**RPSC – Technical Matters Raised at RPSC Committee Meeting, 19th March 2015 and
Subsequent WWTP Visit and LTS Visit
Issue Date 2 April 2015**

The following questions were raised at the Committee Meeting and the subsequent visits on 19th March 2015. In order to advance these the following question and answer sheet has been prepared by Jim Bradley (TAG Chair and RPSC Facilitator) and Greg Manzano (RDC Project Manager).

Figure 1.0 Reative Particle Sizes (Koch, 2004)

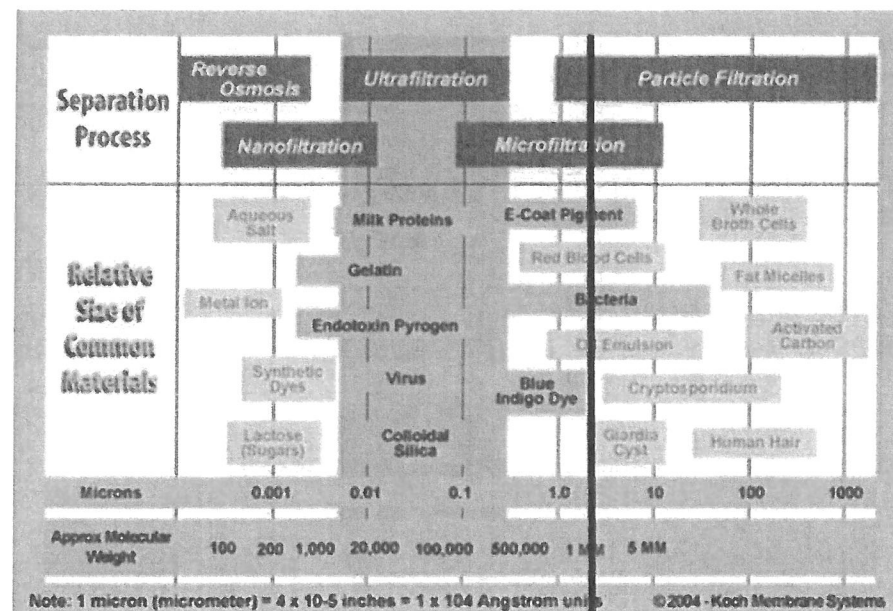
Marked up particle size graph given out at RSPC 19th March showing the Rotorua WWTP MBR with the 4 micron pore (membrane hole) size.

↓
Rotorua WWTP – MBR
4 micron pore size (approx location)

- The matter of particle and microorganism size was covered in relation to the discussion on reverse osmosis at the RPSC 19th March. Slide 15 shows the relative sizes of a reverse osmosis membrane pore to a herbicide and pesticide molecule smallest virus, smallest bacteria and giardia cyst.
- During the Rotorua WWTP visit on 19th March, Plant Manager Andy Bainbridge, confirmed that the MBR pore size is 4 microns. This 4 micron pore size has been marked up on Figure 1 Relative Particle Sizes (Koch 2004). This figure elaborates on the relative size presentation in Slide 15 referred to above. It needs to be appreciated however, that the micron scale on this figure is a log scale.
